STAFF REPORT
COMMUNITY DEVELOPMENT DEPARTMENT

HEARING DATE: 5/23/2023
 TO: Mayor & City Council
 FROM: Sonya Allen, Associate Planner
 208-884-5533
 SUBJECT: SHP-2023-0002
 Chimney Peak Subdivision
 LOCATION: 4853 N. Chimney Peak Ave., in the SEC of Section 26, T.4N., R.1W.

Short plat to re-subdivide Lot 18, Block 24, Fulfer Subdivision No. 6, consisting of 1.45 acres of land, into four (4) building lots and one (1) common lot in the R-8 zoning district.

A. Short Plat (date: 2/15/23)

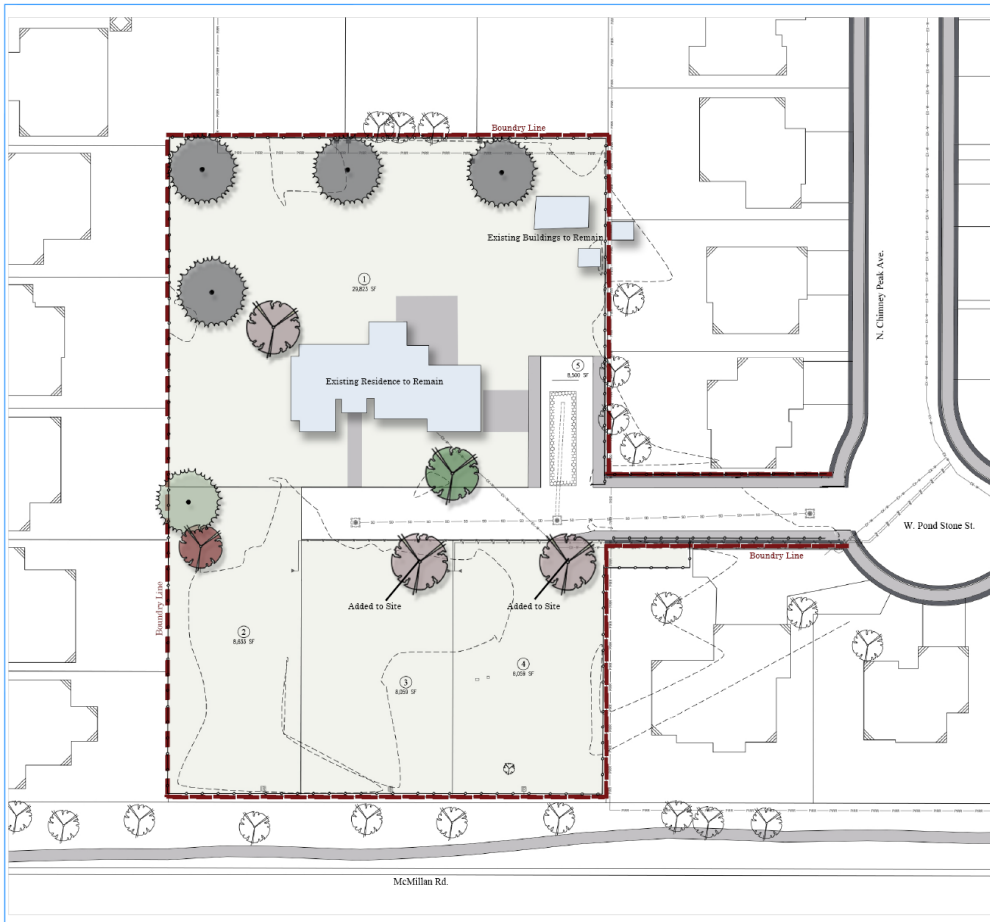
3. The short plat prepared by Joseph D. Canning, Centurion Engineering on 2/15/2023, included in Section VI.A, shall be revised as follows:
 - a. Note #2: Include the recorded instrument number of the CC&R's.

- b. Note #4: "Building setbacks and dimensional standards in this subdivision shall be in compliance with the applicable zoning regulations of the City of Meridian ~~and conditions of the staff report for Chimney Peak Subdivision.~~"

- c. Note #5: "Lots shall not be reduced in size without prior approval from the health authority and the City of Meridian."
 - d. Note #6: " Lots 5, Block 1, is designated as a common drive lot to be owned and maintained by the Homeowners' Association. Lot 5 will provide ingress/egress to all the lots within Chimney Peak Subdivision. The common drive shall have a paved surface capable of supporting fire vehicles and equipment."

- e. Note #9: Include side and subdivision boundary PUDI easements if applicable.
 - f. Note #10: Delete note pertaining to direct lot access via McMillan Rd. (access is prohibited).

D. Common Driveway Exhibit

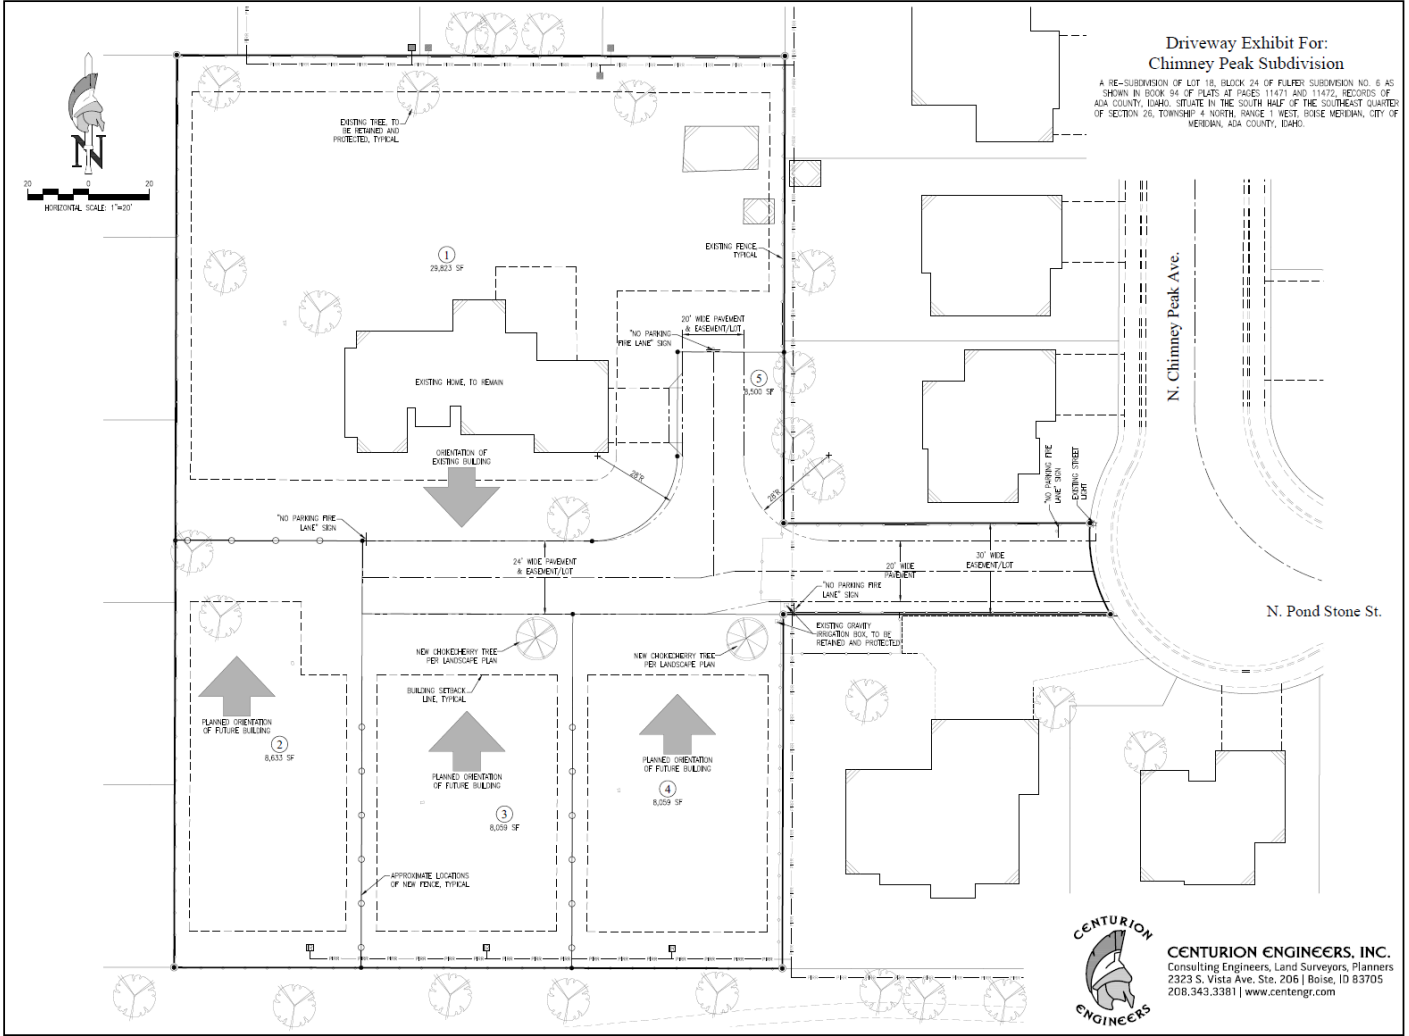
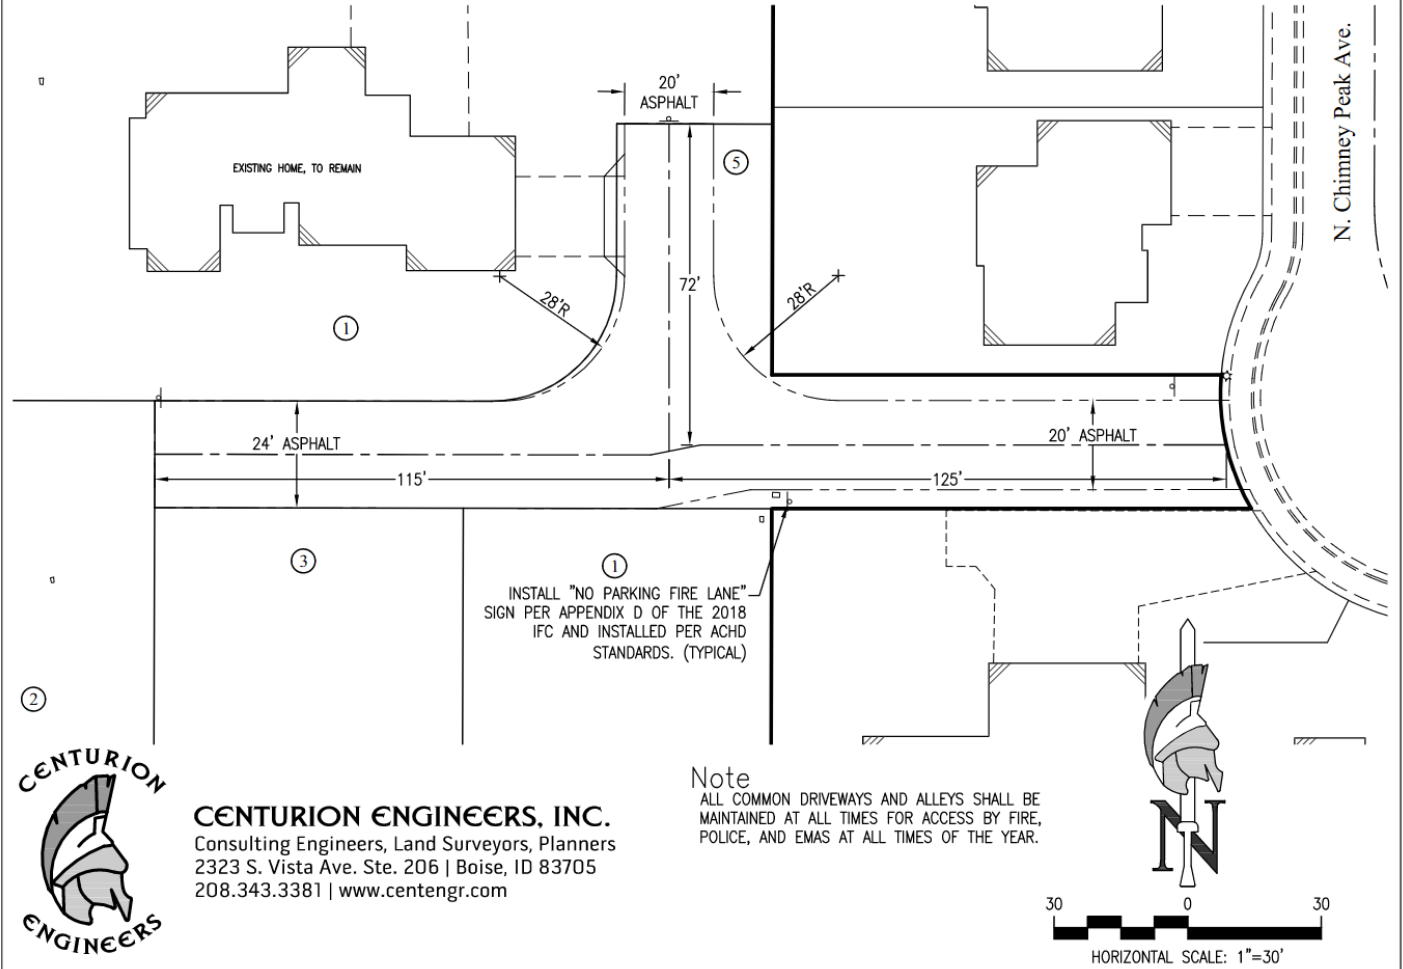
Access to this property is provided via an existing paved driveway from N. Chimney Peak Ave., which will be platted as a common lot for a common driveway that will provide access to all lots in the proposed subdivision. Direct access via W. McMillan Rd. is prohibited. The Fire Department has approved the design of the proposed common driveway and turnaround. A common driveway exhibit was submitted as shown in Section VI.D that reflects compliance with the standards listed in UDC [11-6C-3D](#).

4. Future development shall comply with the dimensional standards listed in UDC [Table 11-2A-6](#) for the R-8 zoning district and the common driveway exhibit in Section VI.D.
